Application Number: 10/723,046 (Peng et al.) Art Unit 2811 Amendment continued 5 of 16

REMARKS-General

FIG. 7 of the applicant's patent application

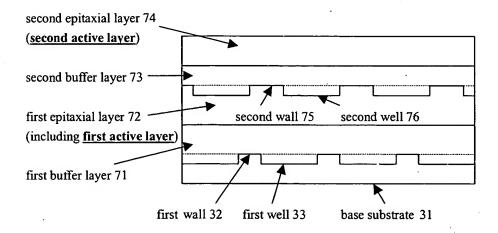
"Claim 9-11 recites the subject matters that a second texture formed on a first epitaxial layer that already comprises an active layer, implying that there are two active layers with the recited second texture there between. It apparently fails to reflect what is described in the specification, in which only one active layer for forming the recited devices is formed above the substrate."

(3) there is <u>only one active layer</u> in Wada's patent (see FIG. 7 of Wada's patent). Actually Wada did not claim the active layer in their claims.

Applicant requests reconsideration and withdrawal of the objection, because that applicant <u>did</u> describe <u>two</u> active layers for the recited device. The following is the quotation from the specification of the original patent application for FIG. 7: "FIG. 7 shows a cross sectional view of epitaxial wafer. First texture comprising well 33 and wall 32 is etched on the top surface of substrate 31. First buffer layer 71 is grown on the first texture of substrate 31. First epitaxial layer 72 comprising first active layer is grown on the top surface of first buffer layer 71."

"Second texture comprising well 76 and wall 75 is patterned by etching on the top surface of first epitaxial layer 72. Second buffer layer 73 is grown on the second texture of first epitaxial layer 72. Second epitaxial layer 74 comprising second active layer is grown on the top surface of second buffer layer 73. Lights of different wavelength emitted from first epitaxial layer 72 and second epitaxial layer 74 are combined and emitted out of device."

There are two active layers emitting two lights of different wavelengths in applicant's patent application. Applicant clearly indicates in new claim 25 that "The semiconductor device of claim 24, further comprises a second epitaxial layer grown on the top of said second texture and comprising a second active layer."
